Engineering Change Notice

Date: 97/09/23	ECN #: 029
Project No.: D205-641	Created By: DS
Project Name:	Checked: KE
	Approved By: DS
	Approved By: N/A
	(PROJECT MANAGER) (MANAGEMENT if reqd)

ADDED LETTERING DETAIL TO D2595

DESIGN	DRAWN BY	DART AEROSPACE LTD VICTORIA INTERNATIONAL AIRPORT, CANADA		
CHECKED	APPROVED	DRAWING NO.		REV. C
DATE		D2595		SHEET 1 OF 1
97:09:23		TITLE		SCALE
		GHW ADAPTER		1:5
A	96:09:16	NEW ISSUE		
B	97:06:27	CHANGED D2578 AND D2591 DETAIL		
C	97:09:23	ADD LETTERING DETAIL PER TSR A370

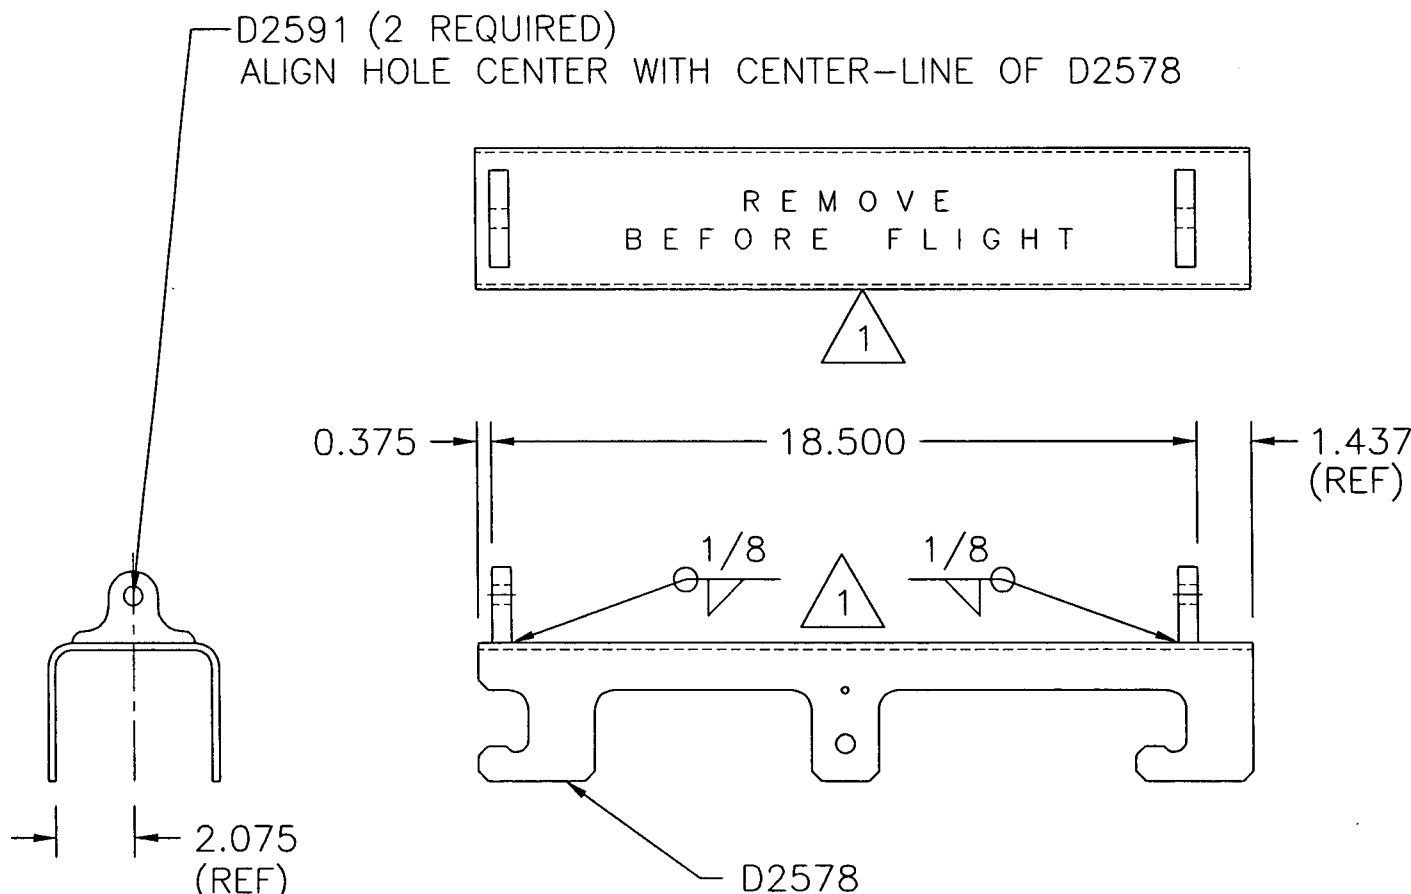
ALL D2595 ADAPTERS IN STOCK OR IN PRODUCTION SHOULD HAVE LETTERING ADDED AS ABOVE. (D2595 REV. C)

NOTE: MARK 'REMOVE BEFORE FLIGHT' IN 0.50 LETTERS
PAINTED RED WITH COPPER/BRASS STENCIL
CENTERED BETWEEN THE D2591 LUGS AS SHOWN
